**Seattle  
Design  
Commission**

**MINUTES OF THE MEETING  
21 November 2002**

Projects Reviewed

**21 Nov 2002 Project: Dexter Court**

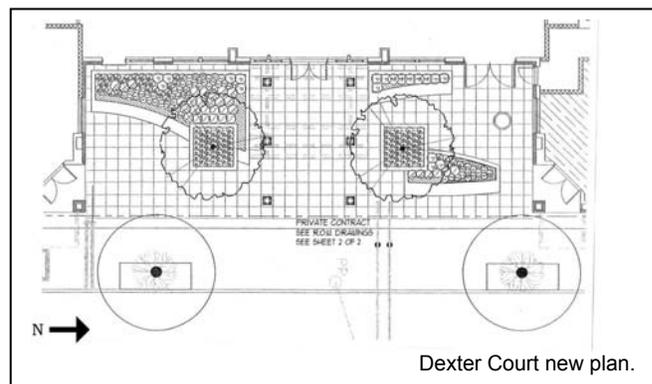
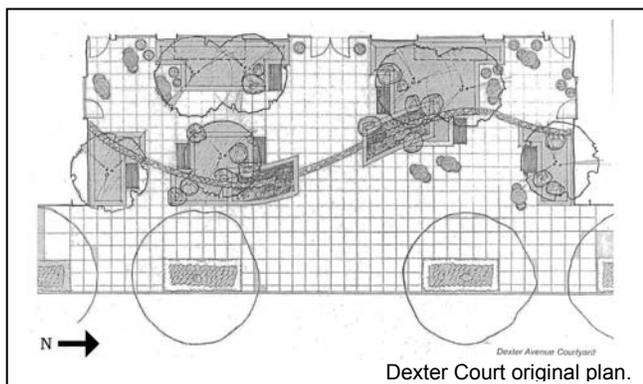
- Would like to know if the original water feature is now plantings.
  - Proponents stated that it is.
- Would like to know what material the awning is.
  - Proponents stated that it is a metal awning.

- Feels that proponents are not being clear enough in what they plan to do.
- Would like to know what exactly the canopy is/includes.
  - Proponents stated that it is a steel canopy with a steel roof in the form of a reverse curve with a chandelier underneath.

- Proponents stated that it is the entry to the building.
- Believes that the point is that the canopy is a major intrusion of a solid overhead plane into the public courtyard. The canopy pushes the building into the courtyard.

- Proponents stated that the water is gone and feel that art can be more compelling than water.
- Feels that they do need to see what the artist develops and how it fits in because there will be a fundamental character change. Believes that the artist needs to be given time to develop her work and no be compromised by being brought into the project so excessively late.

The plaza at Dexter Court has been modified because they revised the interior spaces and changed the corner entrances. The main revision is that there is amenity space in the interior and the changed outdoor space is meant to better tie into that. To do this the original curve has been flipped and the water feature has been eliminated. In the old scheme, the plaza was 480 ft<sup>2</sup> with seven trees; the new scheme is 528 ft<sup>2</sup> with eight trees. The benches remain the same. The primary element to change was the common space—

proponents wanted to create a bigger outdoor space to the north, but the gathering spaces remain basically the same. A covered roof structure has been added and the water feature is pulled back to create a bigger entry. Several street trees have been moved to allow for underground utilities, but the larger landscaped areas are the same as previously presented. Street tree type has been determined, but proponents are unsure of what was decided. The trees in the courtyard itself will be small, multistem trees. Other plant materials include grass, small shrubs, perennials, and flowering groundcovers. The paving in the property line will be 2'x2' stone pavers and outside the property line will be 2'x2' concrete pavers. The paving under the awning is angled to pick up on the diagonal of the flooring in the entry.
